## ENGINEERING BULLETIN

### Grain Cart Oiler Excess Oil Issue

RELEASE DATE: 9/17/2010

#### TO ADJUST THE LUBE MINDER PUMP FOR PROPER OIL OUTPUT

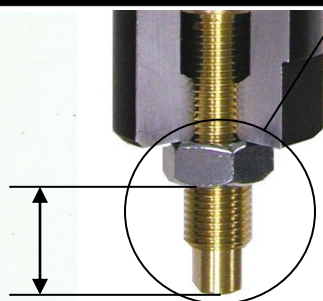
Balzer is seeing instances of excess oil from the automatic chain oiling system splashing into the horizontal auger clutch area. This can cause the clutch to slip resulting in heat build up. The caliper seal may then fail. In the short term we recommend reducing the amount of oil placed on the chain. This is done by adjusting the screw on the lube minder system as follows:

1. First, loosen the jam nut on the bottom of the oiler and
2. For Less Oil – Turn Screw up
3. For More Oil – Turn Screw down

Note: Do not exceed 15 turns in any one direction!

Turning Screw up  
gives less oil

Please inspect the clutch area. Remove any oil on the rotor with brake cleaner or hot water.

We are working on a deflector shield to keep this oil away from the clutch area. We will do our best to get this out in a timely manner. Also inform the operators to never open the grain doors more than half way prior to starting the horizontal auger. This puts excess load on the clutch during start up.
